COMMUNITY PLANNING, DEVELOPMENT & INNOVATION

Re: West End Homes Annexation, Zoning, and Subdivision 1st Sufficiency Review

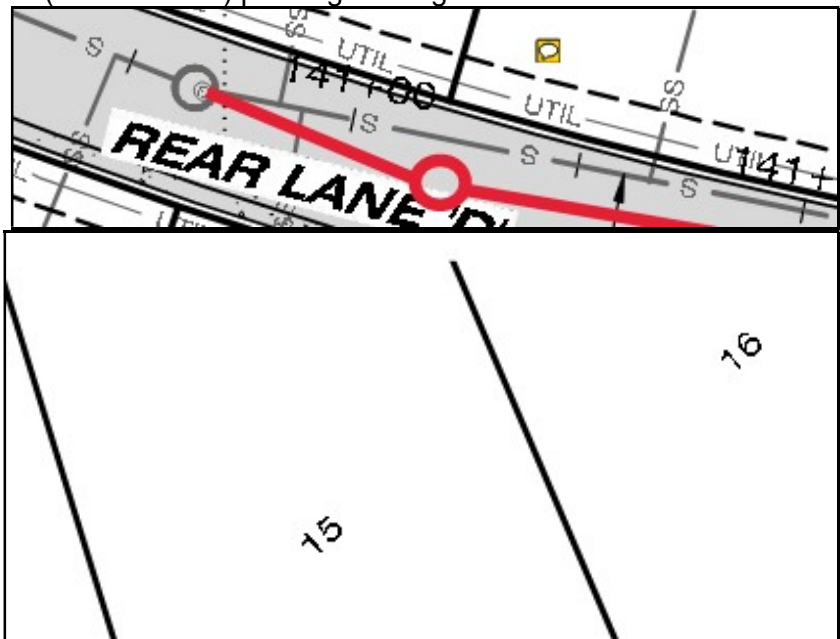
- Sheet 10 – Adjust Sewer Main C alignment and manholes to keep main centered and structures away from cove gutter (shown below) per Engineering.

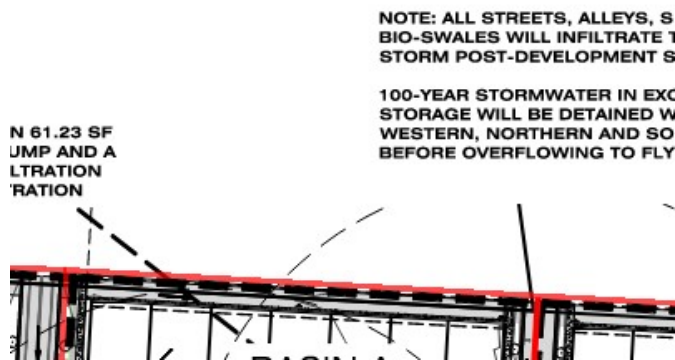
- Drainage Basin Map - How is the composite curve number being calculated for individual lots? The curve number in lots should be based on proposed impervious/impervious area. This could be done with a standard lot layout, pervious/impervious area required by zoning, ect...

- The stormwater report will need to include calculations for how stormwater is routed between subbasins to the ultimate off-site discharge point. Inter-basin routing is required for sub-basins that discharge water from one sub-basin into another. The calculations should include any intermediate flow channels, detention basins or culverts. These calcs are required to support post-development 100-yr discharge rates crossing the site boundary. The attached figure has an illustration of where Engineering anticipates inter-basin flow calculations will be required.
